UNITED STATES
NUCLEAR REGULATORY COMMISSION
REGION III
799 ROOSEVELT ROAD
GLEN ELLYN, ILLINOIS 60137

Reports No. 50-329/82-07(DETP); 50-330/82-07(DETP)

Facility Name: Midland Plant, Units 1 and 2

REPORT ON CABLE INSTALLATION
MIDLAND PLANT UNITS 1 AND 2

SK-25 Unique Case

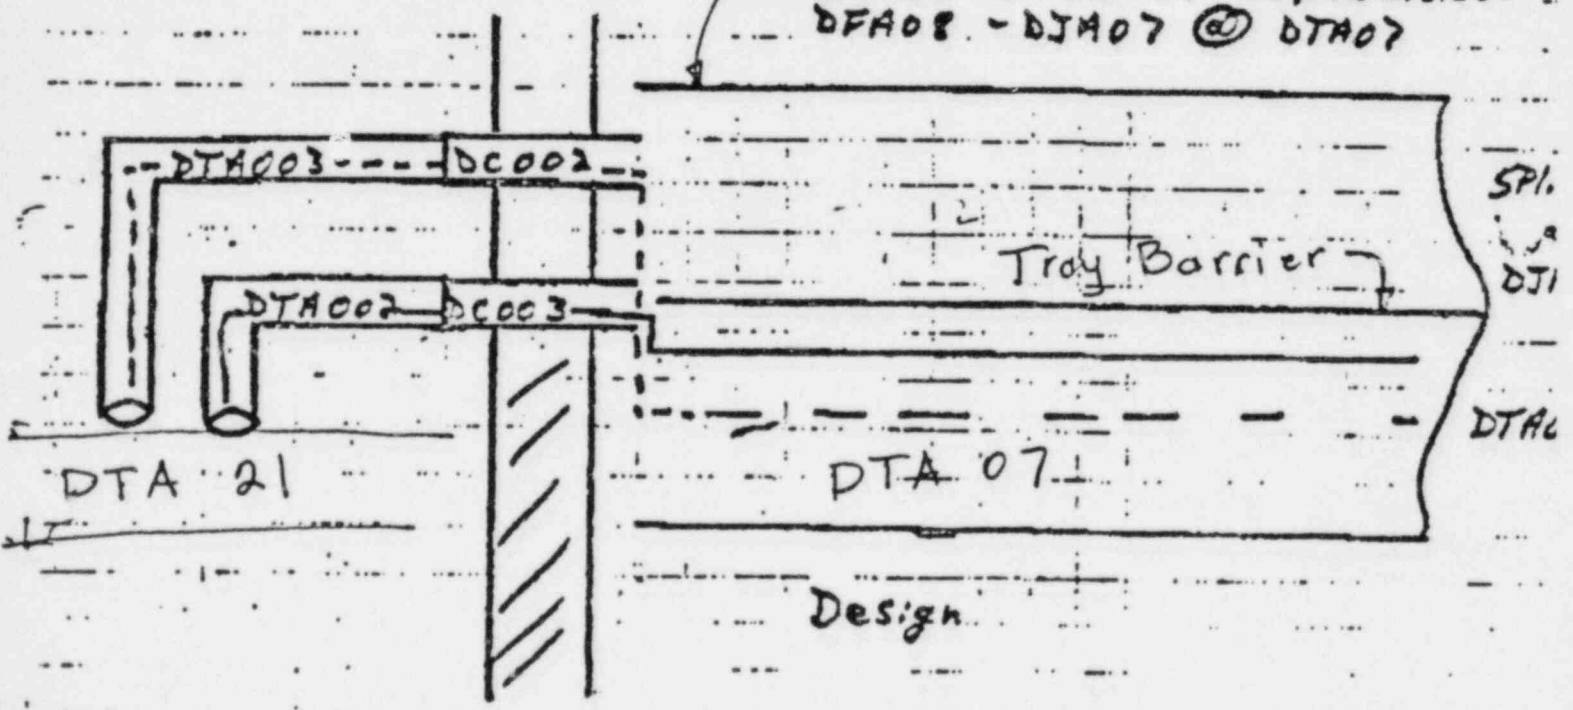
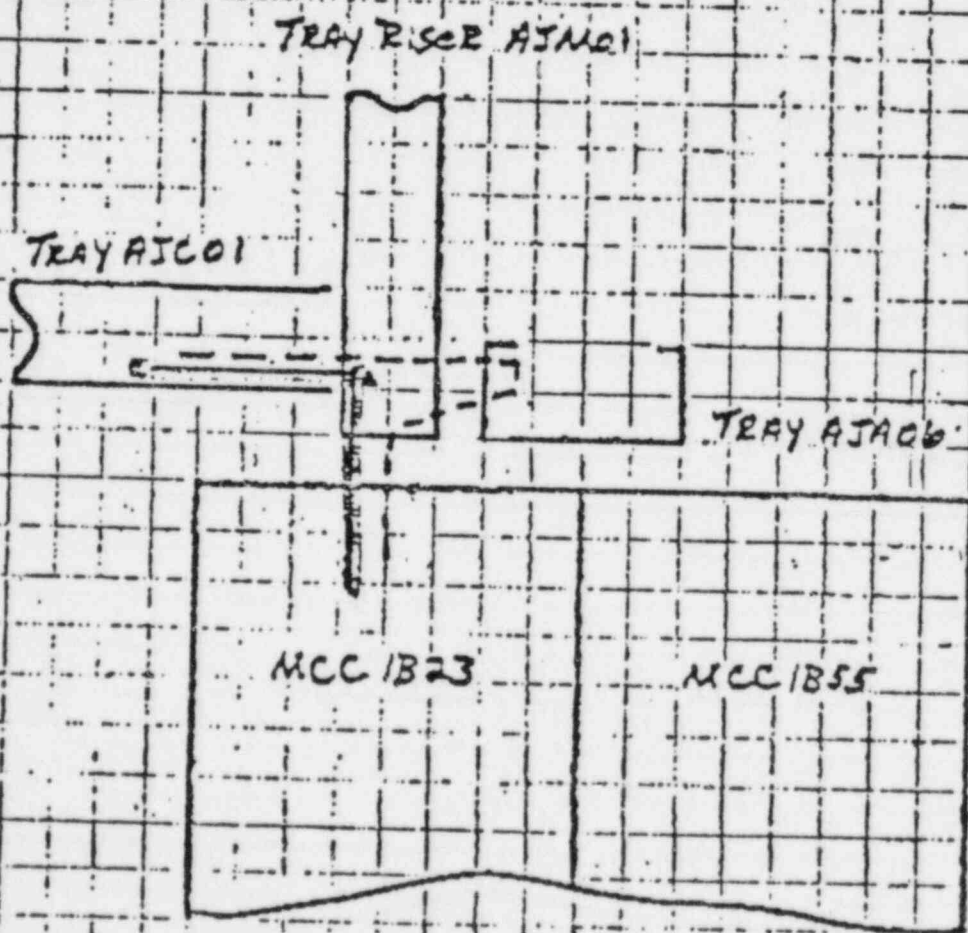
Sixteen small instrument cables were pulled into the wrong conduit.

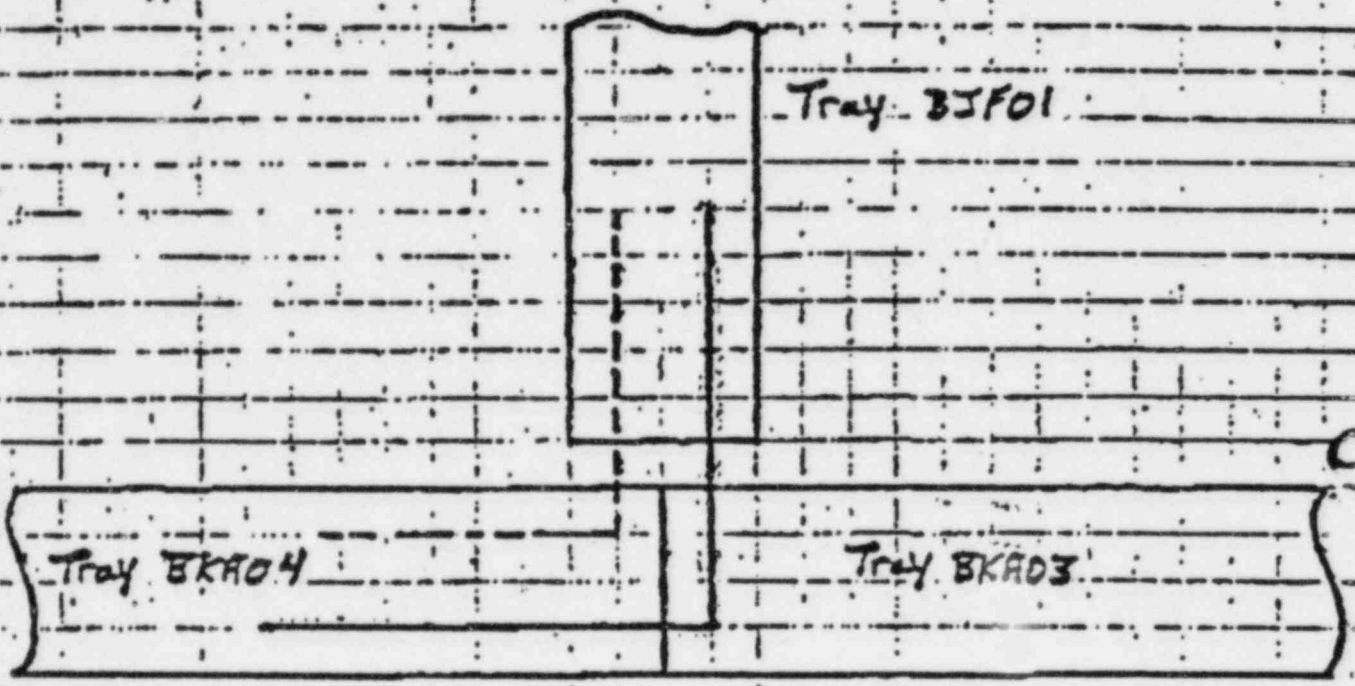
The subject cable enters the confines of an additional raceway. If the trays containing subject cable were required to be wrapped, how do we make sure that the cable portion in the unlisted via is protected.

When a cable enters the confines of additional vias, the tray wrapping criteria would require wrapping approximately 12 more inches at each end for safety.

SK-14

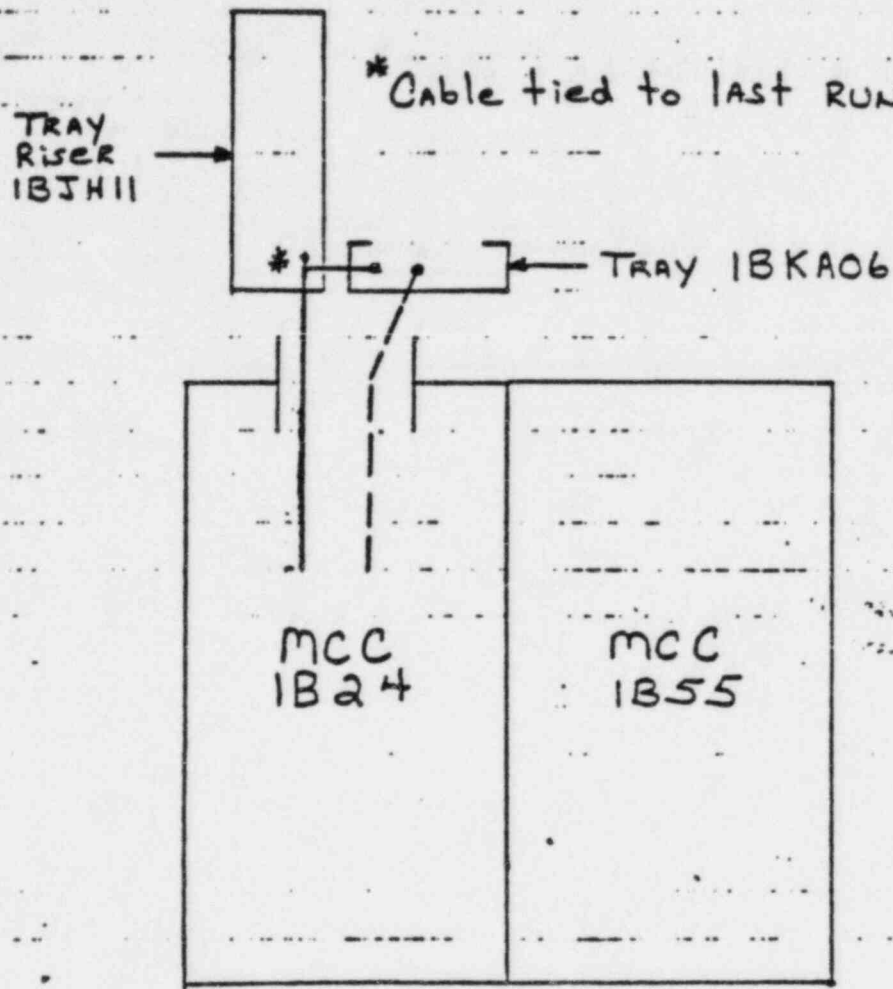
The subject cable enters the confines of additional raceway. If the trays containing the subject cable were required to be wrapped, how do we make sure that the cable portion in the unlisted via is protected.

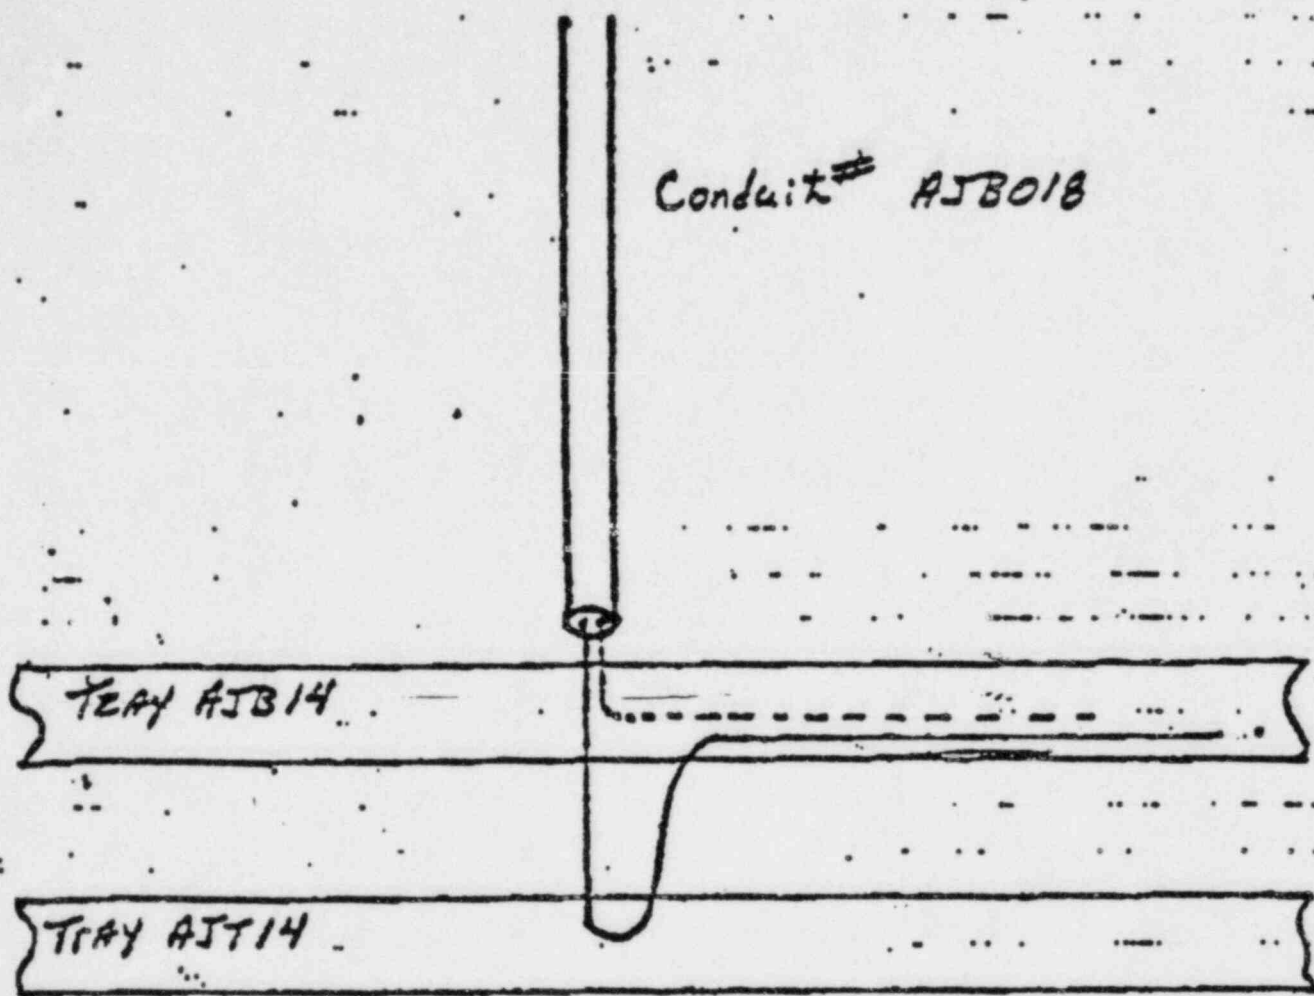
Cable is pulled into BJH11 which was not one of its assigned
vias.

The cable is only tied to the last rung of the riser, and will
not contribute to thermal loading of the riser.

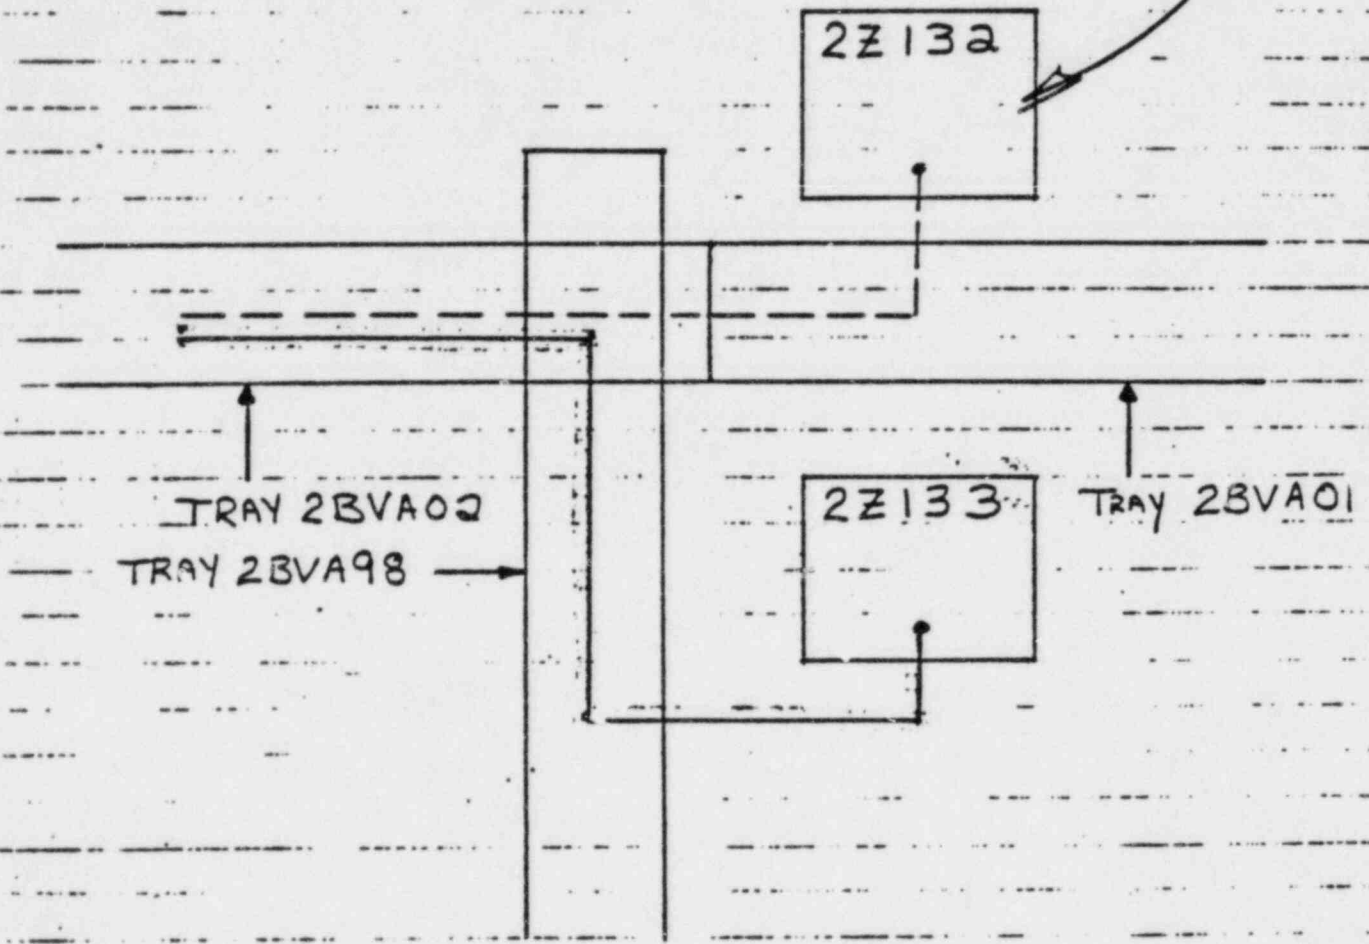
*Is this a
~~problem?~~ segregation*

As a normal procedure, construction eliminates all slack from cables before tying them down. With this procedure accomplished, this concern will not be a problem.

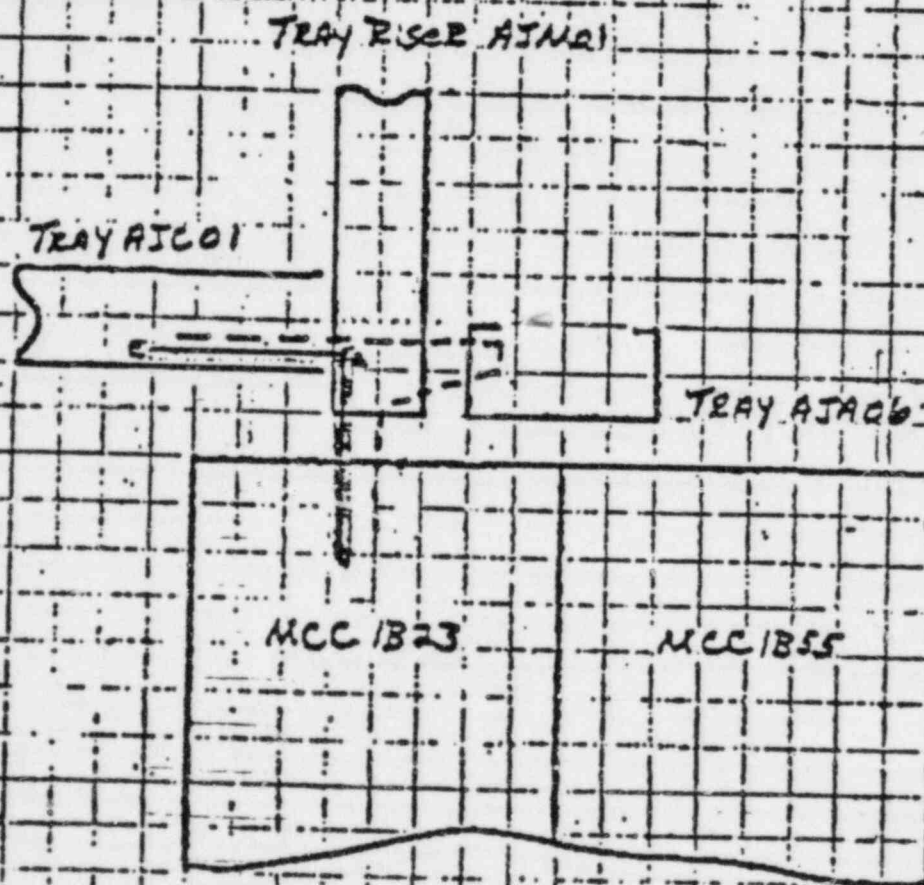
*DTA0157A - segregation problem?
& others*

Crosscom. Co. but correct?
